Piper Aircraft Corporation
Vero Beach, Florida, U.S.A.

No. 1001

Engine Mount
Inspection/Modification

PA-46-310P Malibu

SKETCH "A"

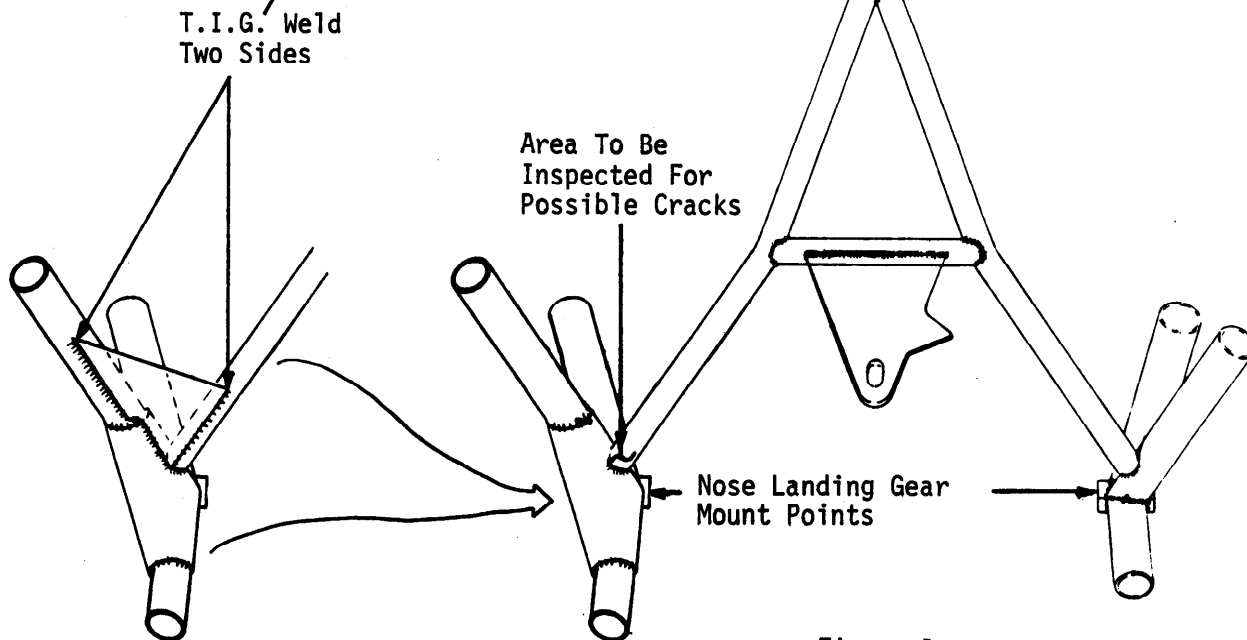
Field reports have been received and examination
of one returned engine mount revealed cracking at the cluster weld near the
righthand nose landing gear mount point.

1. Place aircraft on jacks.
2. Remove engine cowl.
3. Remove righthand turbocharger.
4. Remove engine airbox.
5. Remove nose landing gear assembly.
6. Remove clamps and ties as required to position wire harnesses and hoses
clear of work area.
7. Attach a suitable hoist to engine and relieve loading on the engine mount
prior to any welding.
8. Visually inspect engine mount for cracking at area indicated using a dye
penetrant procedure. Refer to Sketch 'A' Figure 1 attached.
9. If cracking is indicated, clean affected area and repair by TIG welding.

10. After inspection and/or repair, locate and TIG weld in place along two (2) sides, one (1) each gusset, Piper Part Number 84010-48. Refer to Sketch 'A', Figure 2.

NOTE: Gusset may be fabricated from .062" 4130N steel. Refer to Sketch 'A', Figure 3 for dimensions.

P/N 84010-48 Gusset May Be Fabricated
From .062" 4130N Steel
